CITY OF WOODBURN
COMMUNITY DEVELOPMENT

MEMORANDUM

Date: October 5, 2020
To: Dago Garcia, P.E., City Engineer
Cc: Chris Kerr, AICP, Community Development Director
Roy Hankins, PE, Emerio Design
From: Colin Cortes, AICP, CNU-A, Senior Planner *cc*
Subject: **Planning Division review comments on 2nd submittal / 1st re-submittal
Sept. 18 of civil engineering plans for Smith Creek Development Ph. 3B**

SMITH CREEK PHASE 3B

CURB RETURN - NE CORNER OF KILLIAN AND AUSTIN 8
1" = 5'

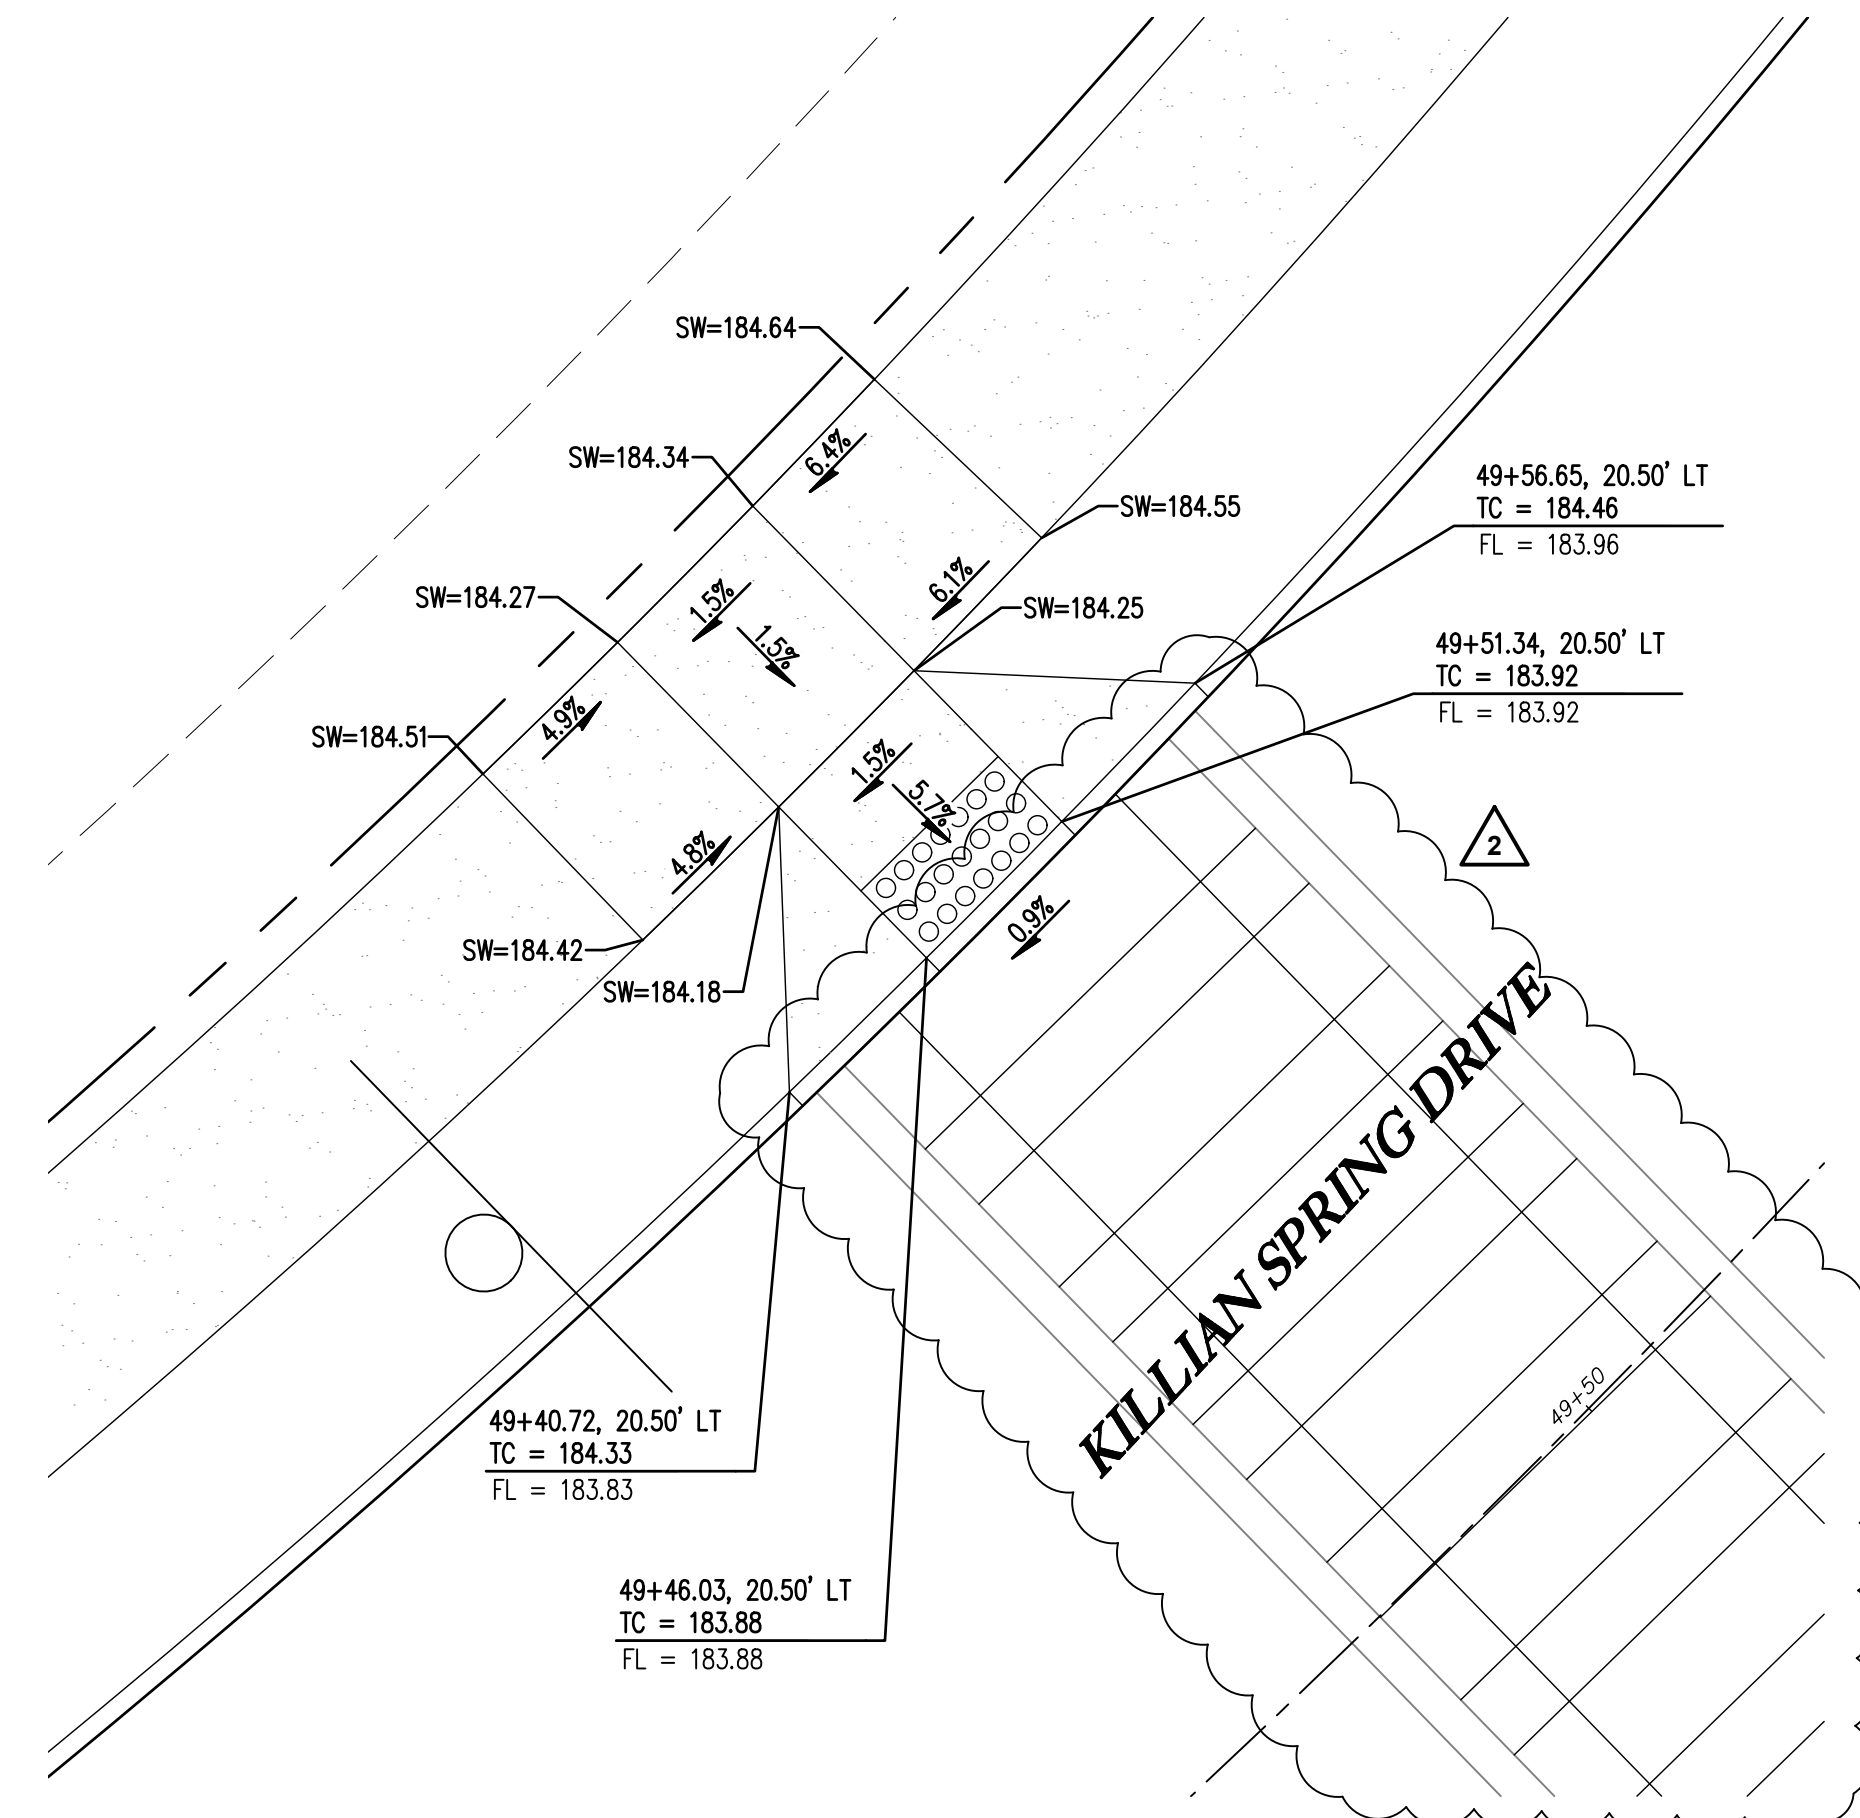
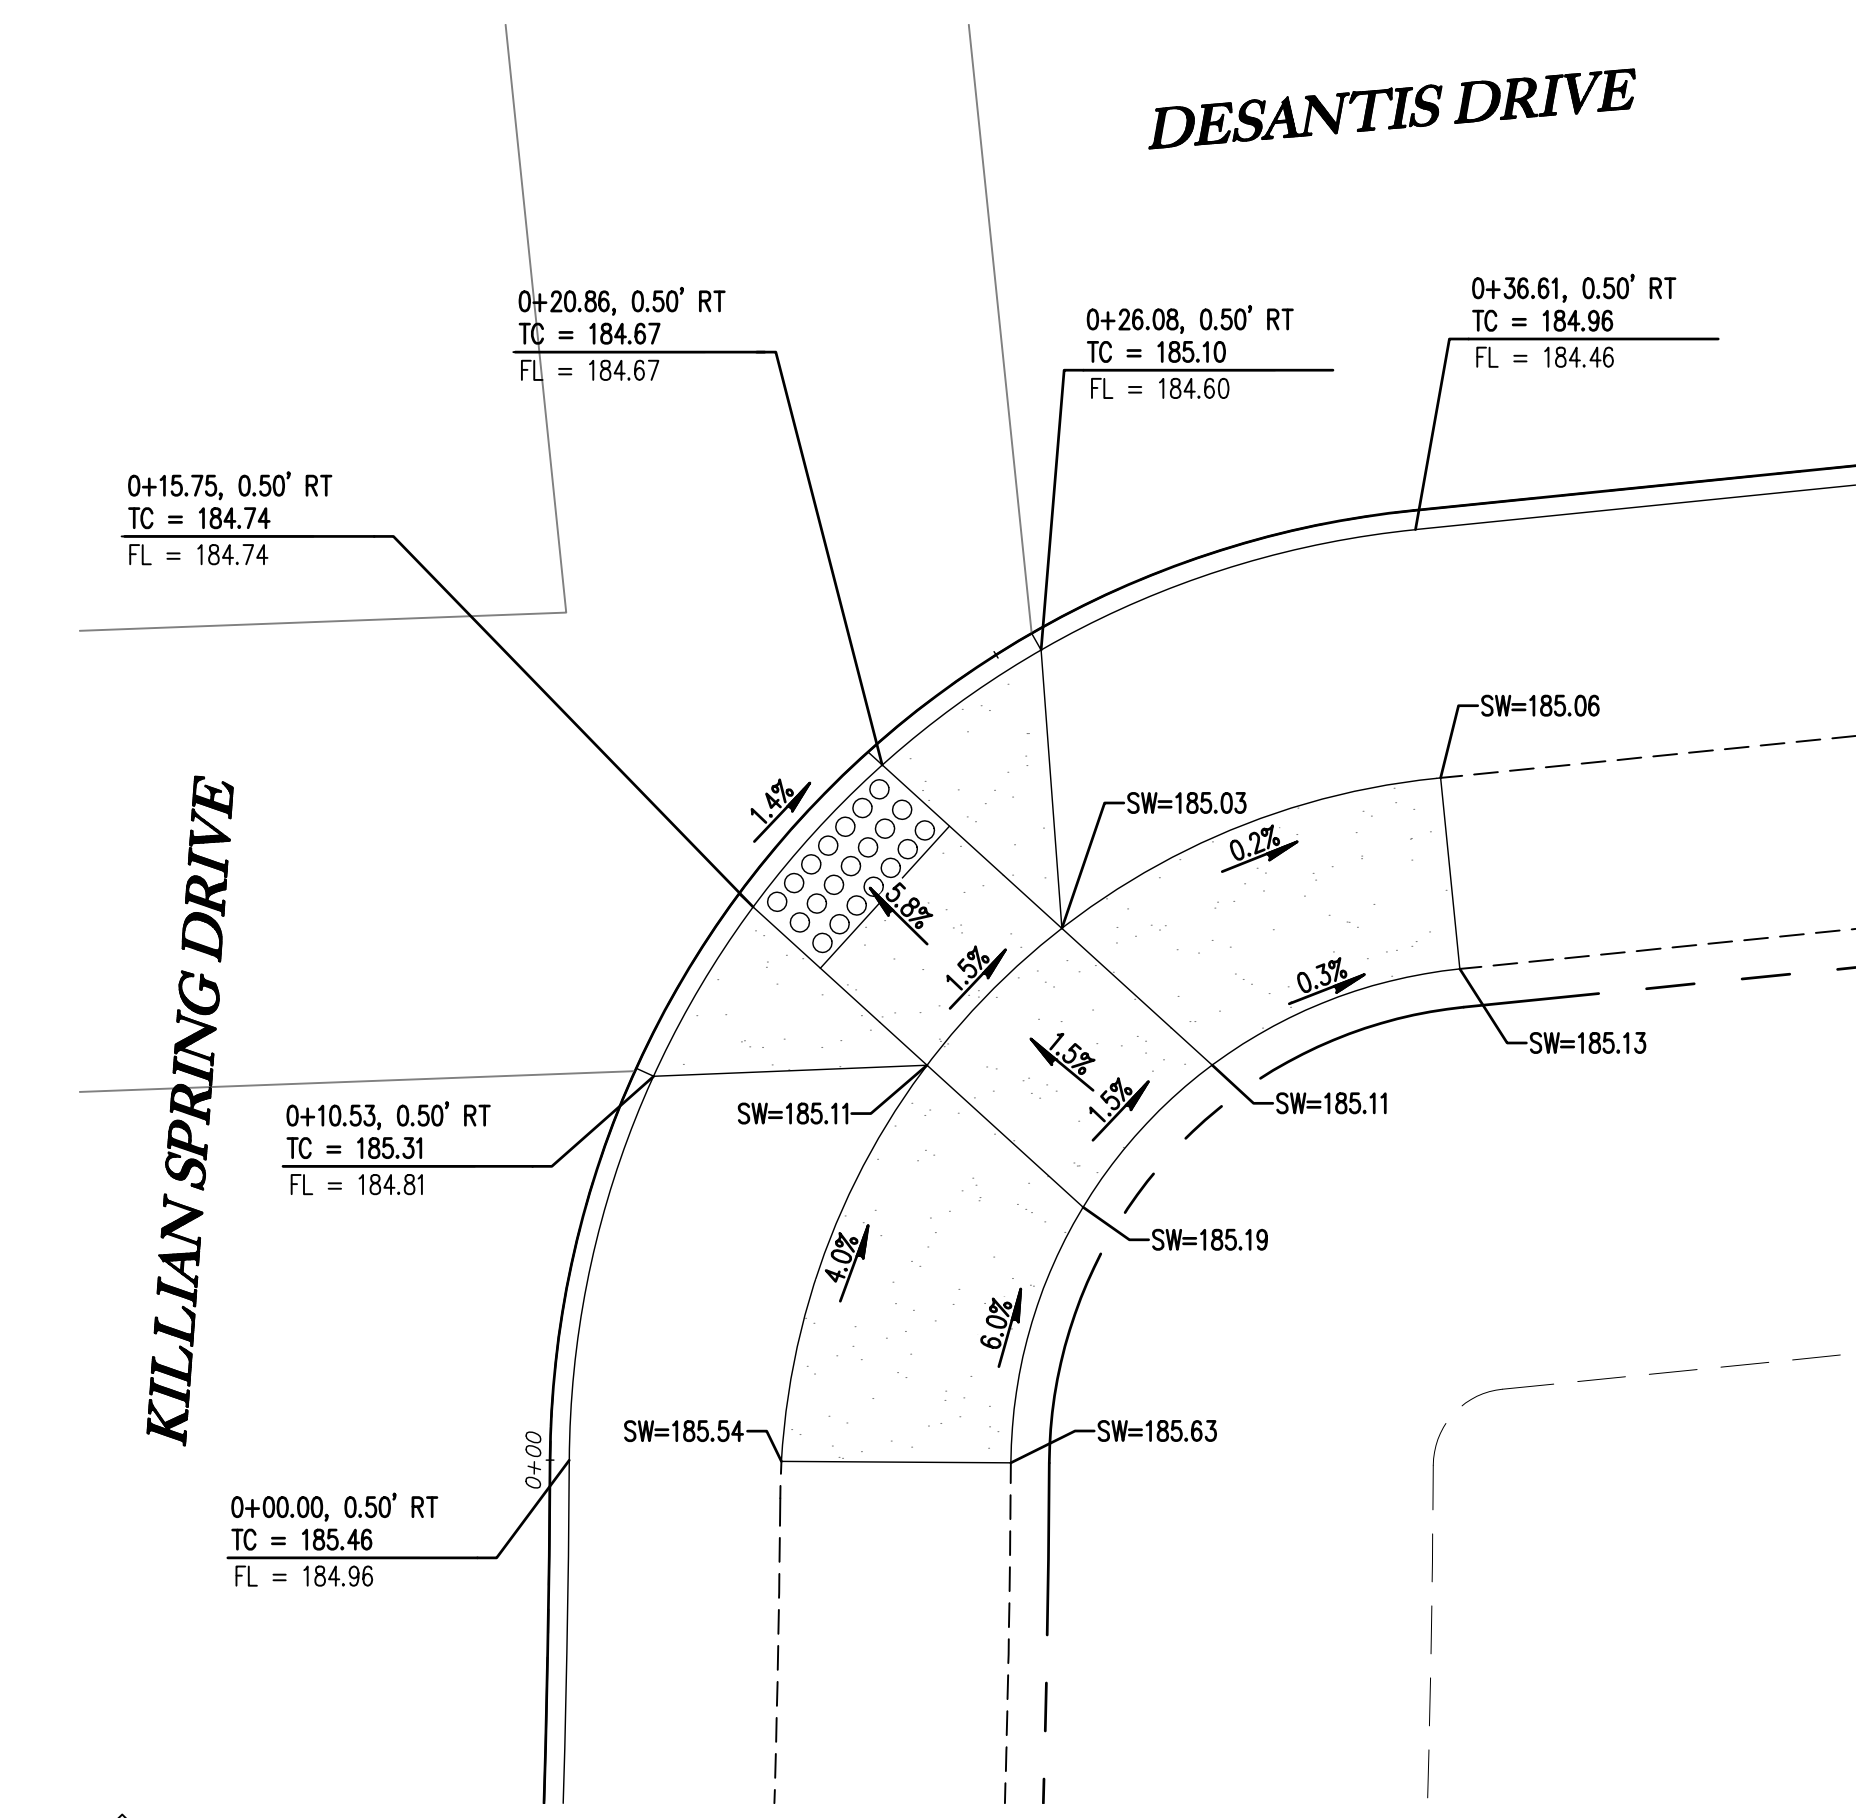
Sheet 3: Stamped concrete crosswalks typical section; and

Sheet 16: Curb return details 7, 9, 10, & 12:

The information is too vague to indicate pavement stamping/treatment, color, and pattern in conformance to the attached excerpted memo I'd sent Stafford Land Co. in August 2019 in response to a request to staff to direct on these topics when the issue first arose for Smith Creek through Phase 1A civil engineering plans.

Patterns: The pattern does not match any of the approved patterns. Thumbnail views of Attachment 1P are below:

Revise Sheets 3 & 16 accordingly.
